ADDENDUM NUMBER 2

Project: Additions and Renovations to
Washington County VA Animal Shelter
15050 Lee Highway
Bristol, Virginia 24201

Date: October 11, 2023

DATE		06-30-2023
NO.	REVISION DATE	
1	10-05-2023	
2	10-11-2023	
3		
SHEET		
A703		
DRAWN BY		CHECKED BY
PROJECT NO		TLG-22138
THE LANE GROUP INC.

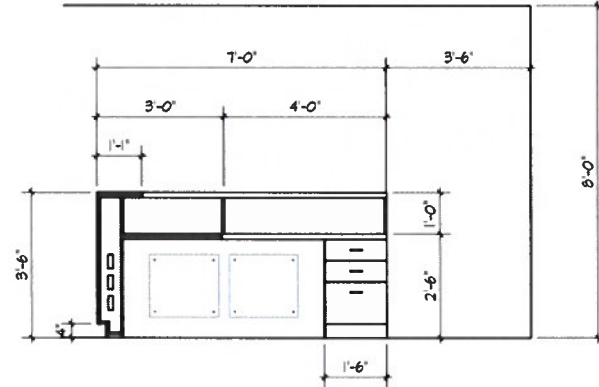
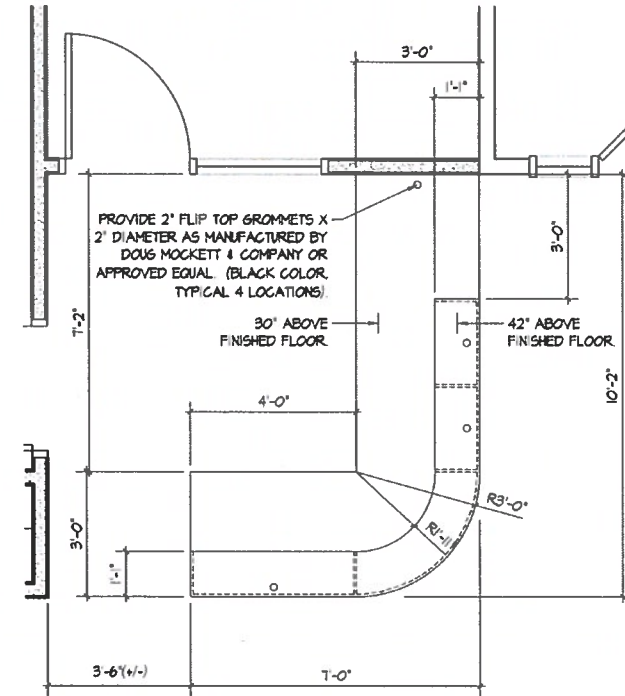
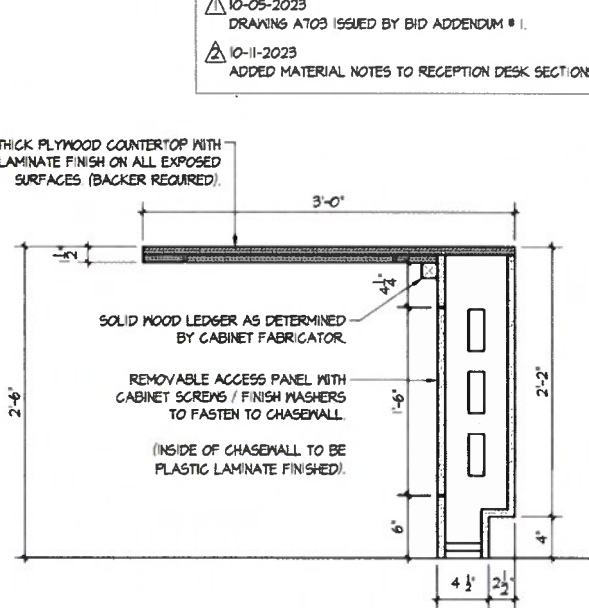
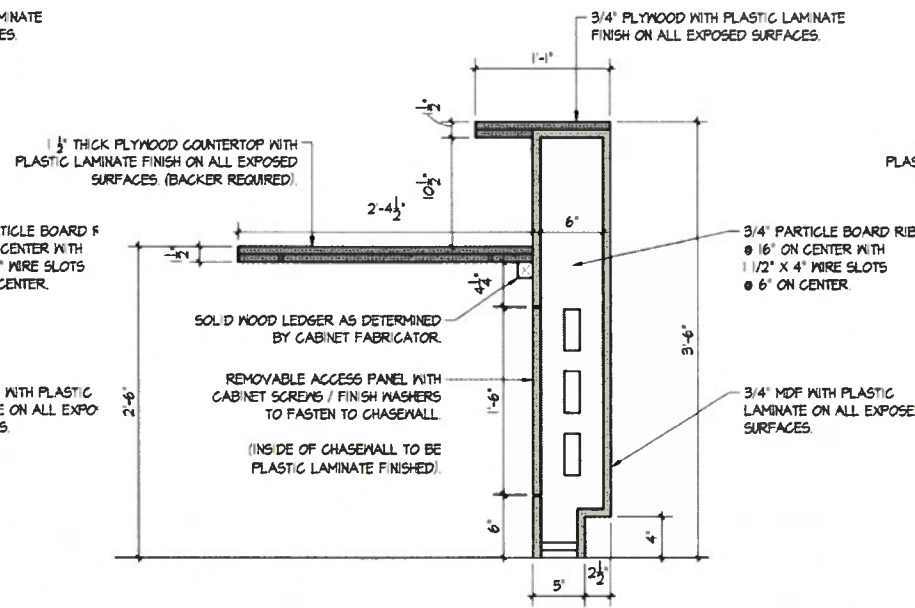
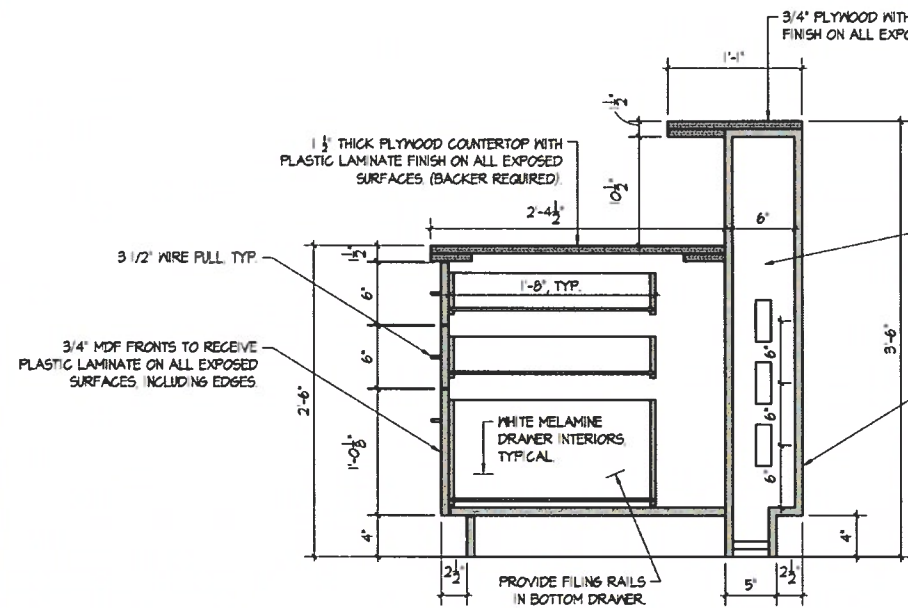
10-05-2023
DRAWING A703 ISSUED BY BID ADDENDUM # 1.
10-11-2023
ADDED MATERIAL NOTES TO RECEPTION DESK SECTIONS.
